08V-282
(8 Pages)

Safety Defect and Noncompliance Report Guide for Equipment
PART 573 Defect and Noncompliance Report¹

On JUNE 18th, 2008, Supreme Corp. [MFR] decided that (a defect which relates to motor vehicle safety)(a noncompliance with Federal Motor Vehicle Safety Standard No. N/A) exists in items of motor vehicle equipment listed below, and is furnishing notification to the National Highway Traffic Safety Administration in accordance with 49 CFR Part 573 Defect and Noncompliance Reports.

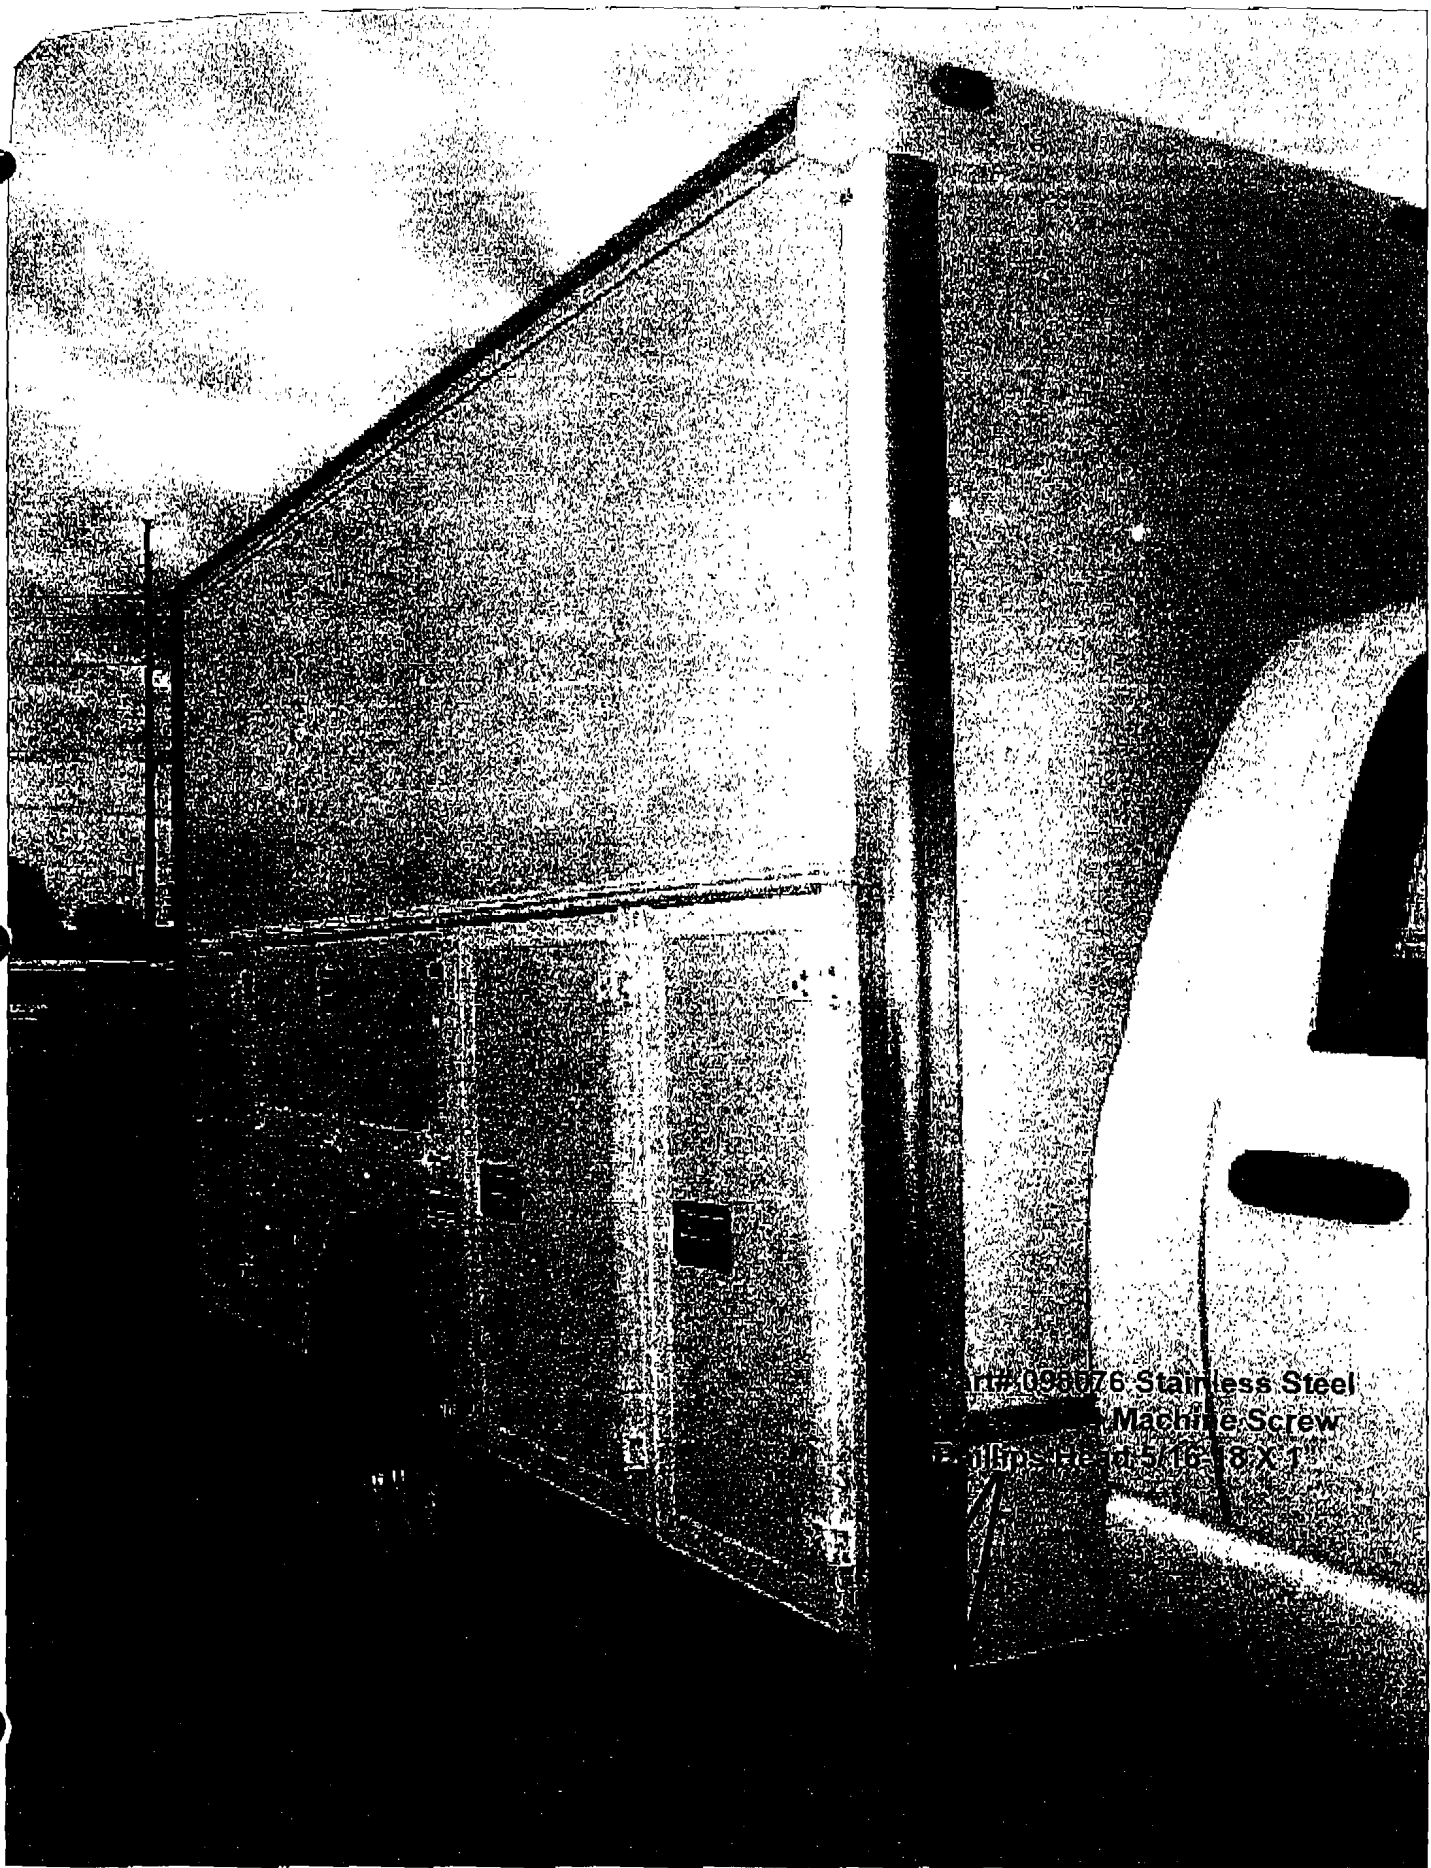
THE ROOF OF THE UTILITY VEHICLE DISLODGED
(CAME OFF) WHILE IN-USE. THE REAR CORNER POSTS AND
FRONT CORNER POSTS COULD DELAMINATE OVER TIME.

FAILURE OF THE ADHESIVE TO SECURE THE SUB-
ASSEMBLIES OF THE BODY.

June 19th Production was informed to install fasteners to secure the individual subassemblies. See photos from Question 8.

Art# 096076 Stainless Steel
Machine Screw
Phillips Head 5/16-18 X 1"
